Access Compliance Report

Public Rights-of-Way

(Curb Ramps)

Intersection ID: 10023893	Main Street: COMMUNITY_HOUSE_RD	Cross Street: N/A	Location: N
ADA ID: B95C2DA608D5	Ramp Type: PerpDiag	Initial Pass/Fail: Fail	Overall Compliance: No
Severity Score: 8.75			
Codes/Mitigation Info/Possible Solution		Field Measurements/Component Compliance

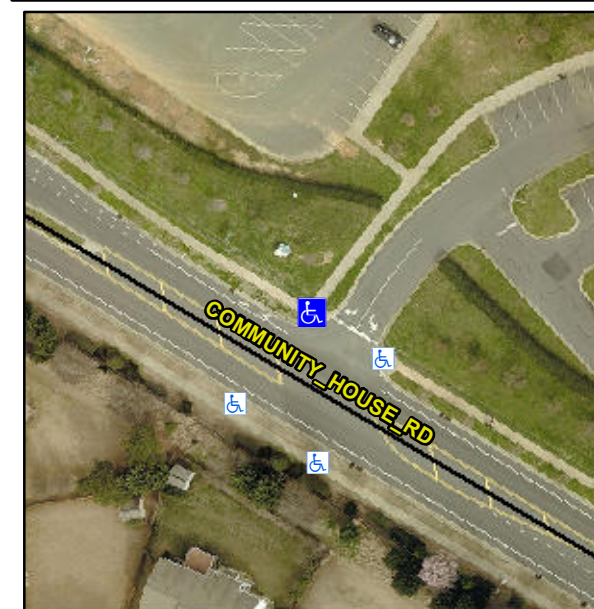
Not Found, R304.5.1

Compliance	Description	Data	Compliance	Description	Data
N/A	Ramp Length (in)	76.0	Yes	Ramp Slope (%)	6.9
No	Ramp Width (in)	38.0	Yes	Ramp XSlope (%)	1.3
N/A	Flare Type LT	N/A	N/A	Flare Type RT	N/A
N/A	Flare Slope LT (%)	N/A	N/A	Flare Slope RT (%)	N/A
N/A	Flare Traversable LT?	N/A	N/A	Flare Traversable RT?	N/A
N/A	Landing Length (in)	N/A	N/A	DWS Provided?	N/A
N/A	Landing Width (in)	N/A	N/A	DWS Contrast?	N/A
N/A	Landing Slope (%)	N/A	N/A	DWS Length (in)	N/A
N/A	Landing X Slope (%)	N/A	N/A	DWS Full Width?	N/A
N/A	Landing Curb? (Y/N)	N/A	N/A	DWS Offset (in)	N/A
N/A	Shared Landing?	N/A			
N/A	Gutter Ponding?	N/A	N/A	Gutter Slope (%)	N/A
N/A	Gutter Lip Ht (in)	N/A	N/A	Gutter X Slope (%)	N/A
N/A	Painted X Walk1?	No	N/A	Painted X Walk2?	No
	X Walk 1 Direction	To SW		X Walk 2 Direction	To SE
N/A	X Walk 1 Width (in)	N/A	N/A	X Walk 2 Width (in)	N/A
	X Walk 1 Slope (%)	1.5		X Walk 2 Slope (%)	0.9
	X Walk 1 X Slope (%)	0.6		X Walk 2 X Slope (%)	0.0

Remove & Replace Curb Ramp With Two New Directional Ramps or Equivalent.
